**Mullen Trucking, LP
Technical Review Comments**

**Bridge Strike & Collapse
Mt. Vernon, WA
05/23/2013**

**HWY-13-MH-012
(51 Pages)**

Re: Collapse of Bridge Span
May 23, 2013, Mr. Vernon, Washington
NTSB Investigation: HWY13MH012

Figure 4 – Location of the Fracture Critical Members of the I-5 Bridge over the Skagit River

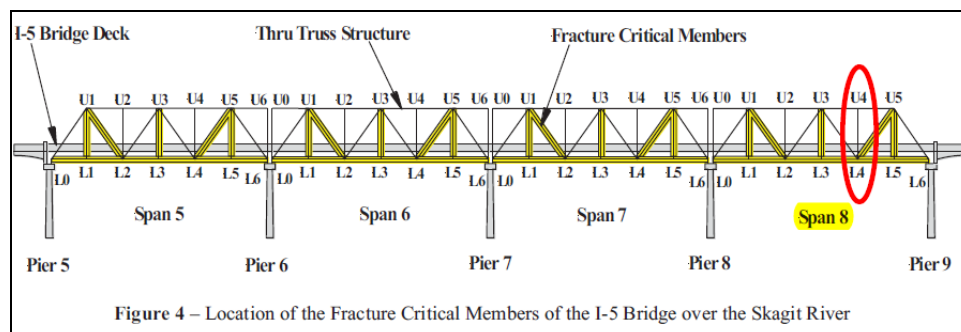
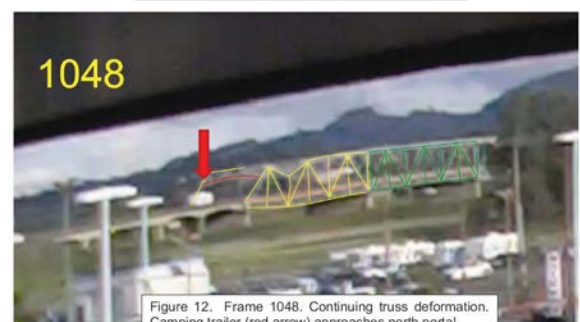
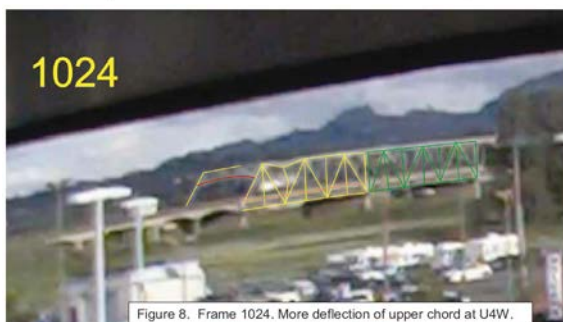
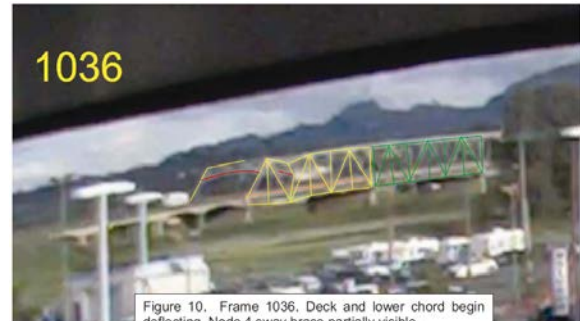
The analysis of the surveillance video performed by the NTSB shows that the connection between the west sway brace 4 to the vertical member U4W-L4W catastrophically failed during the initial stages of the collapse. For reference, here is the node drawing from page 27 of the Highway Report (red circle added):

This connection between sway brace 4 and the vertical member U4W-L4W exhibits significant differences relative to a similar connection between sway brace 3 and the vertical member U3W-L4W, which also sustained heavy impact from the load during the event. Also, a nearly identical connection between sway brace 4 and the vertical member U4W-L4W on span 7 was severely impacted by the load; however, span 7 did not catastrophically fail.

In light of the above observations, we believe a thorough examination of the fractures, materials and fasteners at the connections to the vertical member U4W-L4W are warranted to uncover any potential pre-existing issues that may have contributed to the failure. In addition, historical information on repairs and damage would provide valuable information for the analysis. **The fact that similar connections on span 8 and other spans on the Skagit bridge did not fail in the same manner after the sway brace was impacted indicates that the span 8 to U4W-L4W vertical connections, or other connections that are configured the same, may well have been susceptible to failure.**

With all this in mind, we respectfully suggest that there is insufficient information currently available to determine that “all of the fractures and cracks were consistent with overstress forces.”

Significant portions of the fracture surfaces around the connection of sway brace 4 to member U4W-L4W cannot be examined because they are underneath or obscured by other component members (please see photographs 1 and 2 below). **There is no question that this is a critical fracture area and that it is a key to understanding the sequence of events and failure. It cannot be fully evaluated by visual examination alone. We recommend detailed visual, microscopic and laboratory examination.** We would be pleased to assist with this process, or take the lead under NTSB supervision.

Photograph 5: Node L4W. The area of connection with the U4W-L4W vertical is shown in the circled area.

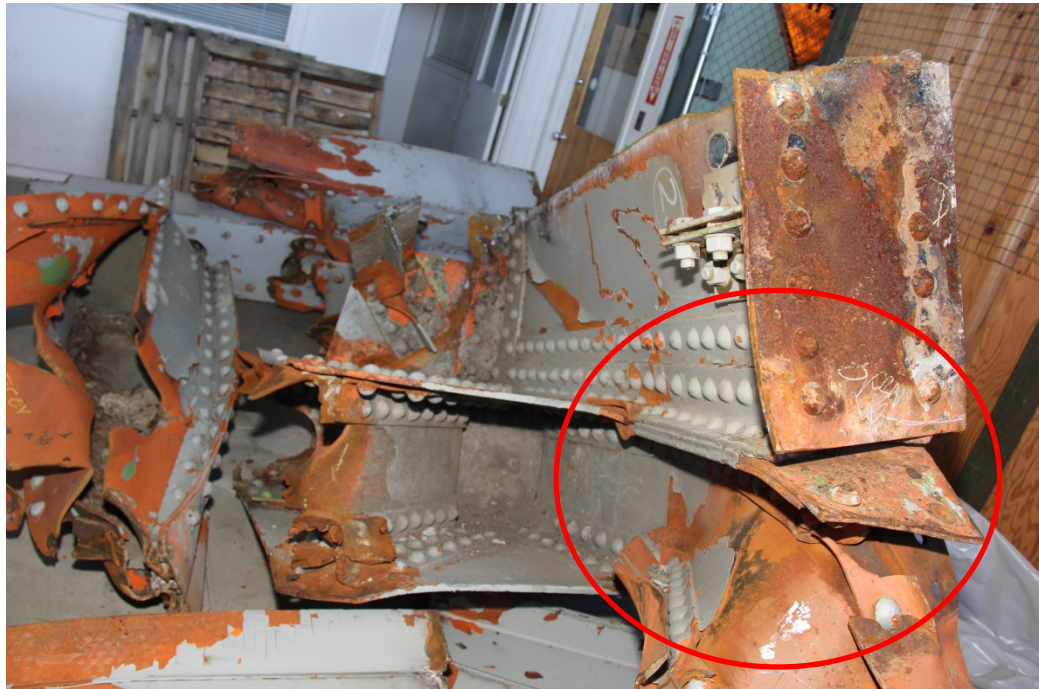
Detailed examination of the connection of the U4W-L4W vertical to L4W node and any associated lateral or rotational displacement will be important for any modeling of the span.

Figure 16. Impact damage to sway brace 4 above with extent of bowing depicted below.

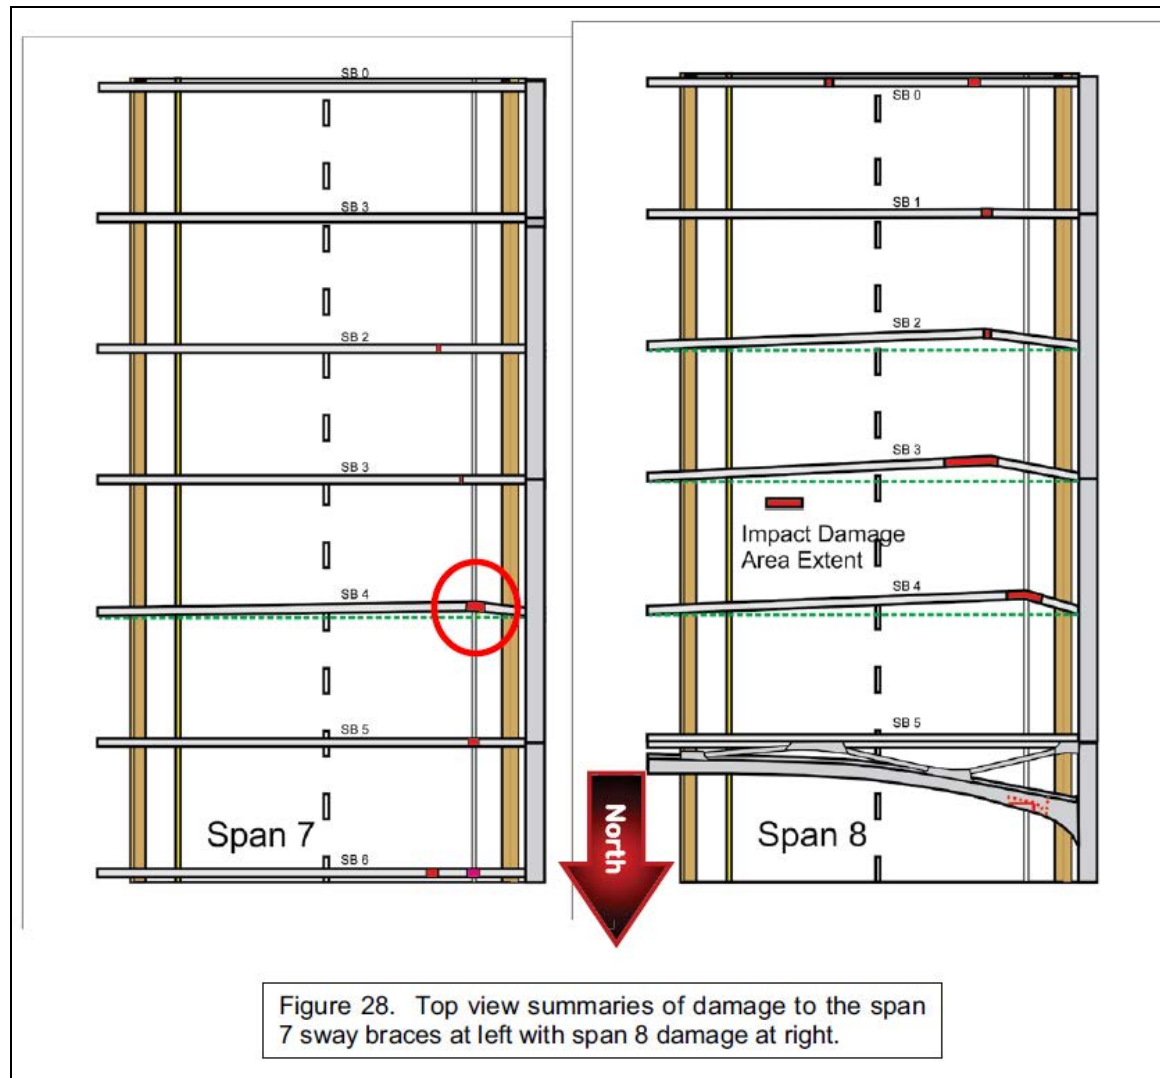
While we do not disagree with the measured approximation of the deflection in sway brace 4, we think it is important to identify and discuss that the deflected condition as measured is post incident and post recovery. Although not specifically stated in the report, we believe that the observed and recorded deflection of span 8, sway brace 4, will be compared with the deflection and damage of the sway braces on span 7, which can be attributed almost exclusively to impact with the load. Figure 28 on page 36 implies that a comparison can be drawn by showing the

deflected condition of both the span 7 and span 8 sway braces relative to a dashed line. We believe this has the potential to mislead the reader.

We request that notation be made that the damage and deflection observed post-recovery in the sway braces on span 8 is likely a combination of (1) impact with the load, (2) the forces of the span collapse itself, and (3) recovery efforts.

Figure 9. At left, node L4W being recovered attached to floor beam 4. Below, two views of bending overstress fractured member L4W-L6W.

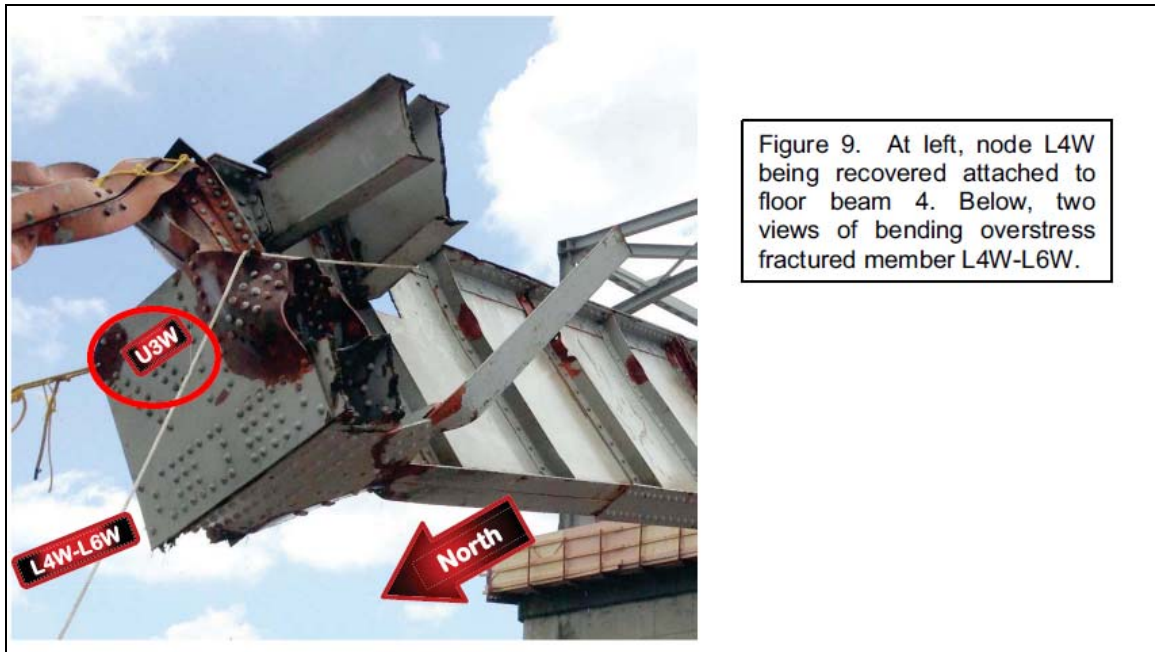
- **Page 20, Figure 9, Top Photograph;**

The node in the photograph below appears to be **L4W**, not U3W. (The label in the photo is mis-labeled. The caption is correct.)

Page 31, Figure 21:

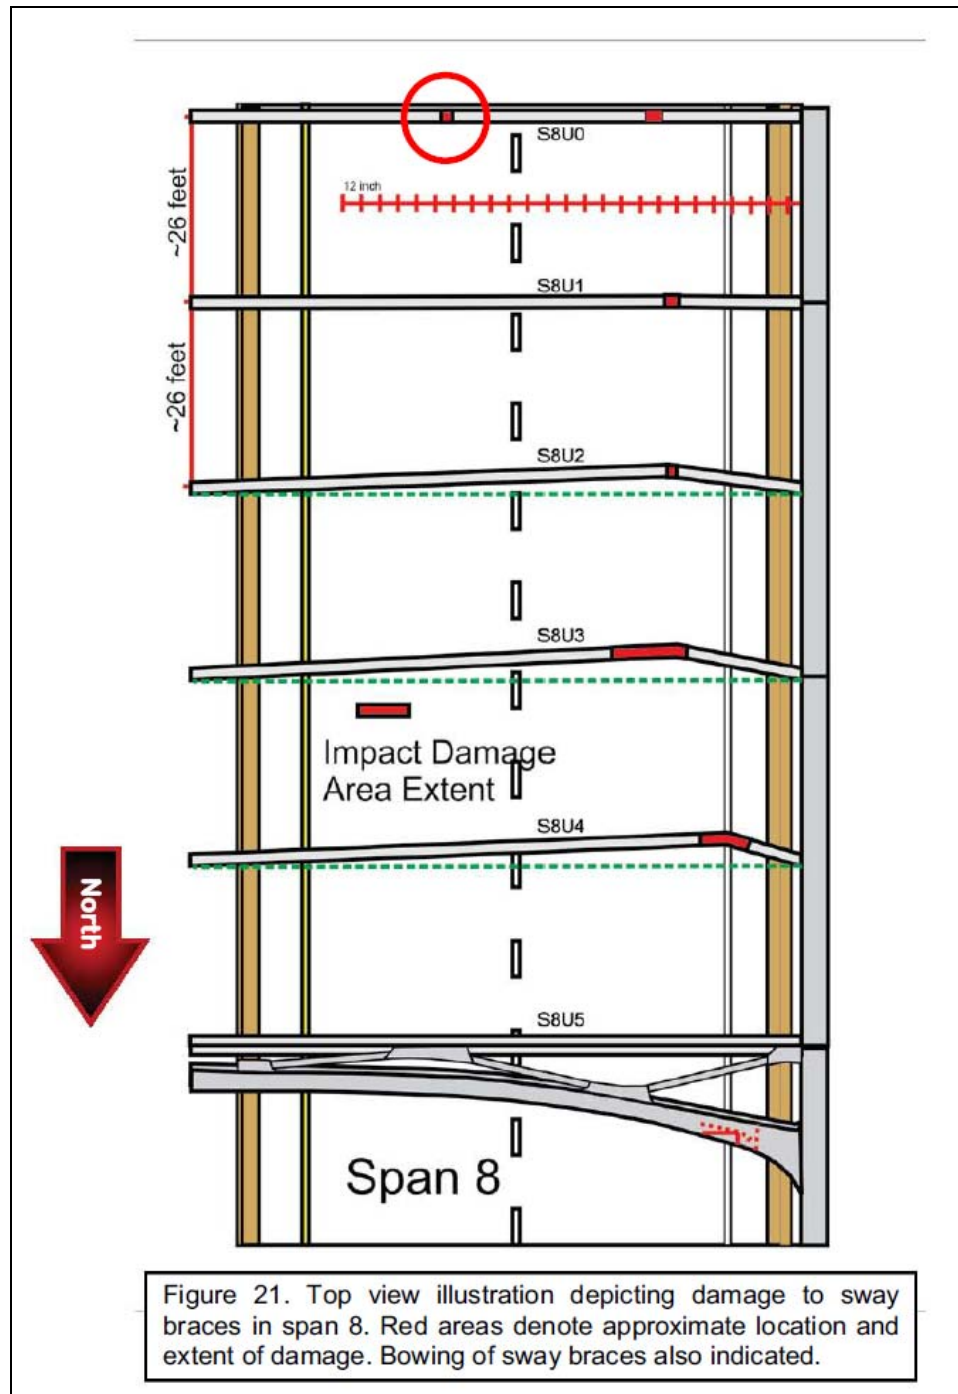
Two damage locations are shown on sway frame S8U0. While the reference to this damage implies that it is accident related, the distance from the inboard damage (circled in red) to the road surface (likely approximately 18 feet) would seem to make it unlikely that it is related to the 05/23/2013 accident. Is there any evidence that this inboard damage is from the subject accident? If not, we recommend that reference to the damage be removed from the report or it be noted that this damage is not likely accident related.

Figure 15 on page 17 highlights a scrape on left the side of the casing shed:

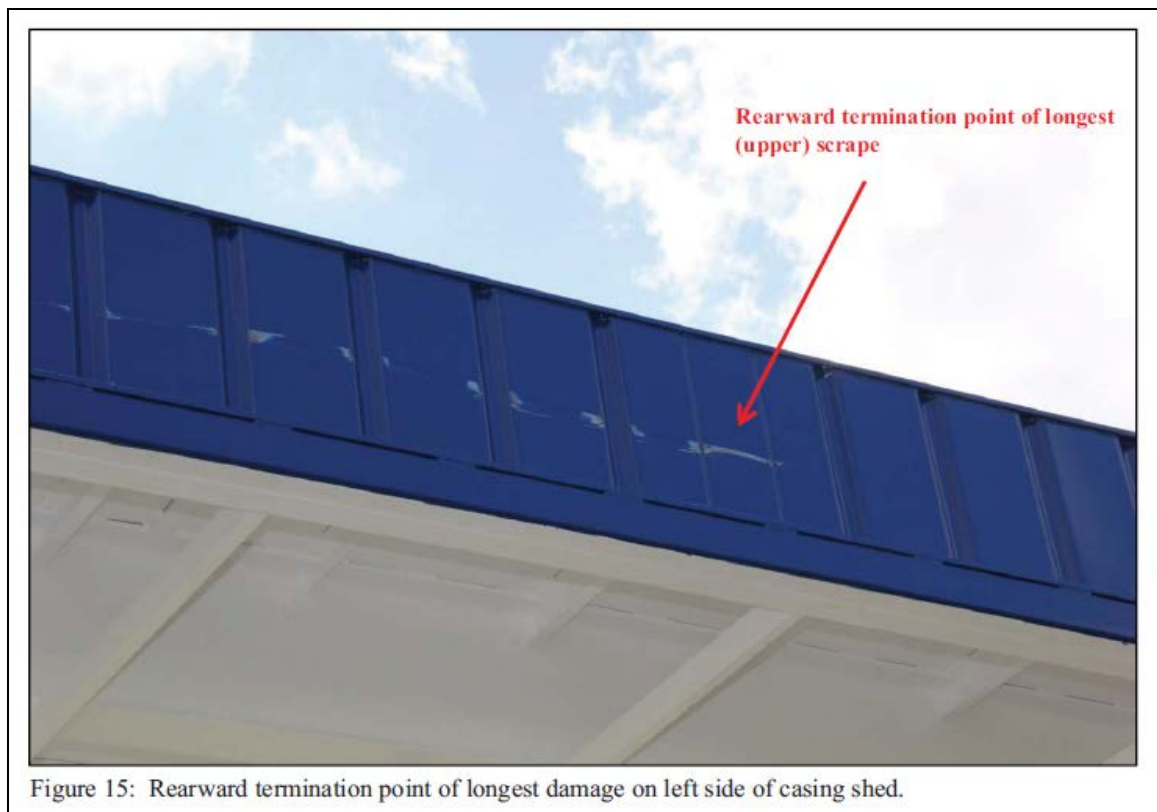
The report goes on to reference and provide 3D post-accident scans of the involved 2013 Subaru Crosstrek (2.3 on pages 18 & 19) and Dodge Pickup Truck (2.4 at pages 20 & 21). No reference, photos or 3D scans, however, are found of the involved 2000 Kenworth truck tractor and 1996 utility refrigerator semi-trailer also involved (and referenced in the Motor Carrier Factors Report at pages 24 & 25 and the Vehicle Factors Report at pages 18 & 19). We respectfully suggest that

Figure 2. Rear view diagram of the pilot car

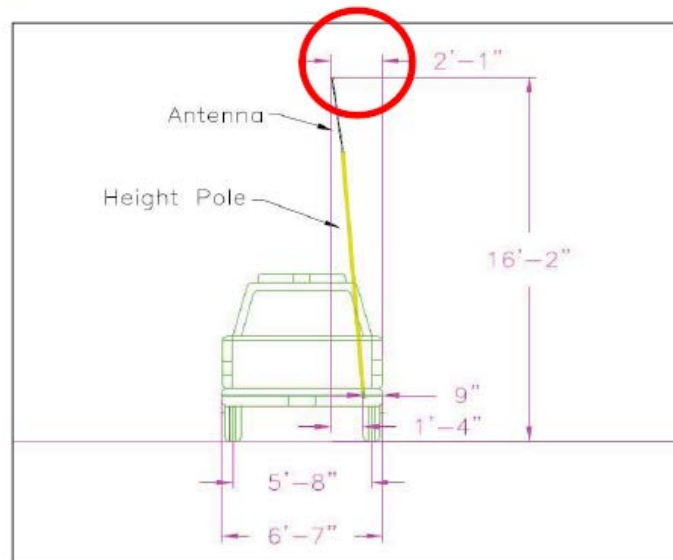
Note is also made that the pole on the Pilot Car was leaned 2 feet 1 inch in toward the center of the car:

We recommend that a comparison be inserted in this report as to the height of the pole as compared with clearances at various locations within the southbound lanes and the sway braces at issue, taking into account the 2 feet 1 inch offset from the right side and possibly using both the 16 feet 0 inch and the 16 feet, 2 inch heights.

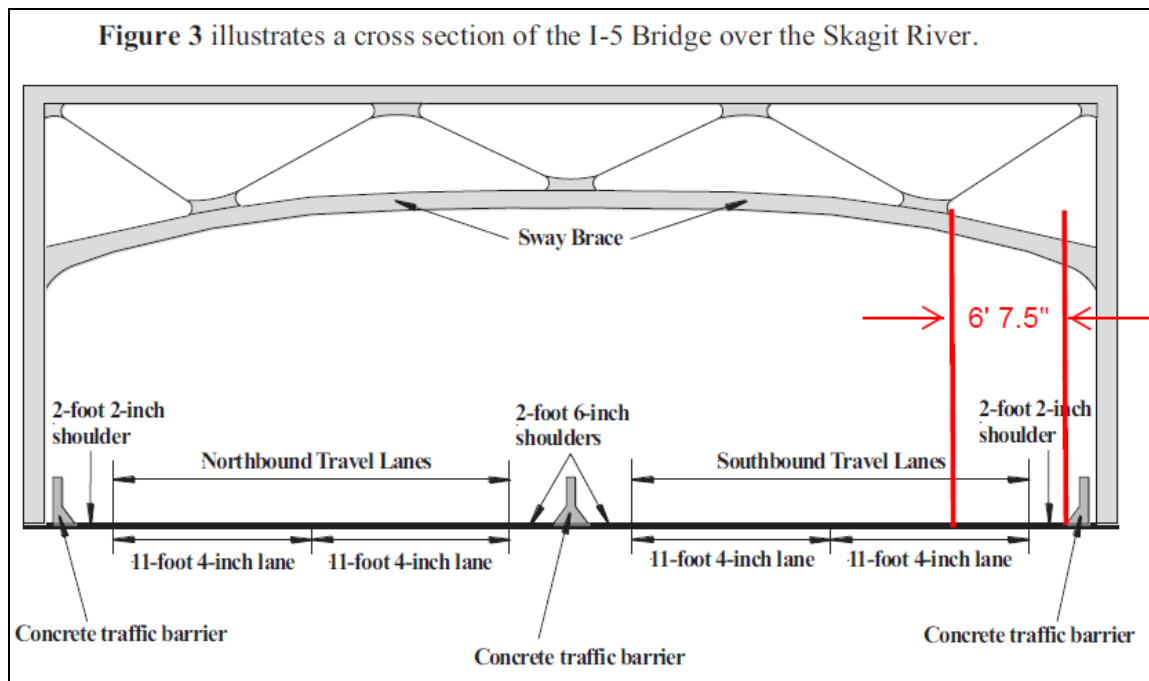
Consider Figure 3 from page 13 of the Highway Report, a copy of which is below. If, for instance, the 6-foot-7-inch wide pole car was in the center of the 11-foot-4-inch right south-bound lane, there would have been 2 feet 4.5 inches before the 2-foot-2-inch shoulder, ending at the concrete traffic barrier. But with the pole another 2 feet 1 inch toward the center of the pole car, the pole itself would have been at least 6 feet 7.5 inches from the concrete barrier (2 feet 4.5 inches + 2 feet 2 inches + 2 feet 1 inch). The red lines have been added to this Figure.

While we do not know the heights from the roadway of span 8 to the sway brace 4, we do have those measurements from the roadway of span 7 to sway brace 6 from Table 13 on page 39 of the Highway Factors Report. This is the closest sway brace for which we have measurements to the accident location.
